YARRA PLANNING SCHEME

SCHEDULE 18 TO CLAUSE 43.02 DESIGN AND DEVELOPMENT OVERLAY

---/---/---
Proposed C273yara

HEIDELBERG ROAD PRECINCTS

Figure 1: Indicative Cross Section and Measurements

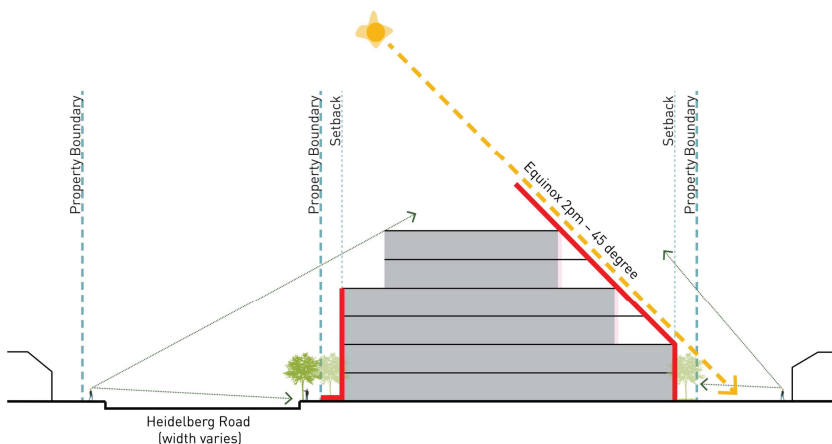
Commented [YCC7]: In response to Submission 5, 34, 54 and 117 regarding improving the rear interface controls.

Upper levels above a rear boundary wall must be set back from the rear boundary and be contained within a 45 degree setback envelope. The envelope's angle is to be measured perpendicular to the ~~applicable development site's~~ boundary or setback, taken from the centre of the boundary.

Development must provide minimum ~~landscape ground floor~~ setbacks to the rear boundary as follows:

- Precinct 1: ~~a minimum of~~ 3 metres (as shown on Map 1);
- Precinct 3A: ~~a minimum of~~ 4.5 metres;
- Precinct 2 and Precinct 3B: All other areas: a minimum of 3 metres if the dwelling on the adjacent residential property is located less than 15 metres from the property boundary.
 - 5 metres where a development site directly abuts a rear boundary of an adjacent residential lot.
 - 3 metres where a development site directly abuts a side boundary of an adjacent residential lot.

Map 1: Building and Street Wall Heights for Precinct 1

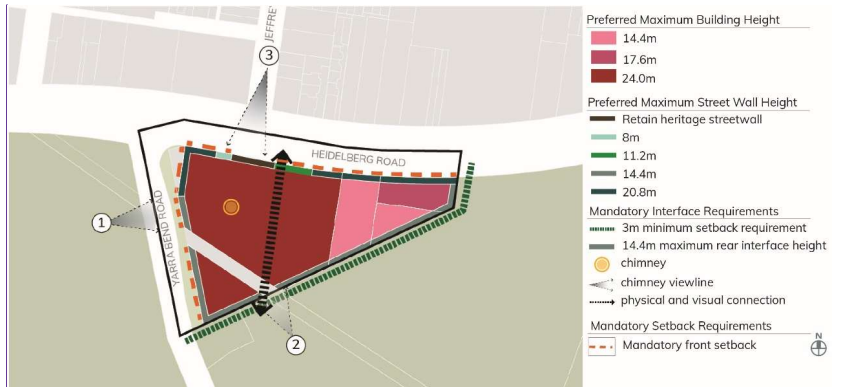
Commented [YCC18]: Officer additions to provide more clarity around the location of the chimney which has been added onto Map 1.
